# UNITED STATES PATENT AND TRADEMARK OFFICE

| APPLICATION NO. | FILING DATE | FIRST NAMED INVENTOR | ATTORNEY DOCKET NO. | CONFIRMATION NO. |
|-----------------|-------------|----------------------|---------------------|------------------|
| 09/632,519      | 08/04/2000  | Russell A. Houser    | 23,393-37           | 1493             |

# Office Action Summary

**DETAILED ACTION**

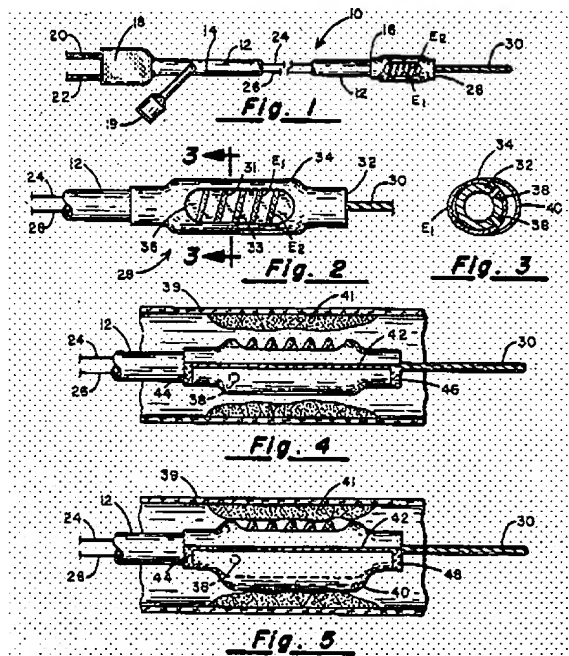
In figures 1-5, the Parins, et al., Patent shows an elongate catheter defining a compartment within the catheter having one window through the catheter wall open to the compartment; a cutting element and a control component coupled to the cutting element. Parins, et al., does not teach the use of a cutting element compressible into a reduced diameter when positioned within the compartment and tending to radially expand beyond the catheter wall when positioned near the window. However, the use of cutting elements that radially expand through a catheter window is conventional in the art as evidenced by the teachings of Okada, et al., and Tihon, et al.

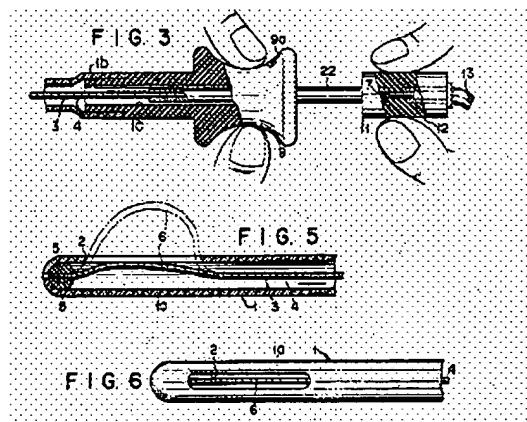
In figures 3, 5, and 6, **Okada, et al.**, teaches the use of a cutting element compressible into a reduced diameter and tending to radially expand beyond the catheter.

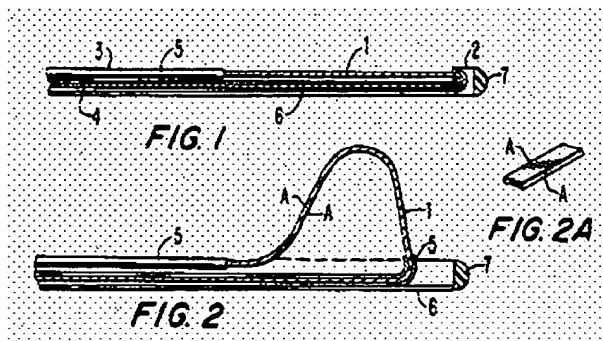
Additionally, Tihon, et al., shows in figures 1 and 2 (below), the use of a cutting element compressible into a reduced diameter and tending to radially expand beyond the catheter.
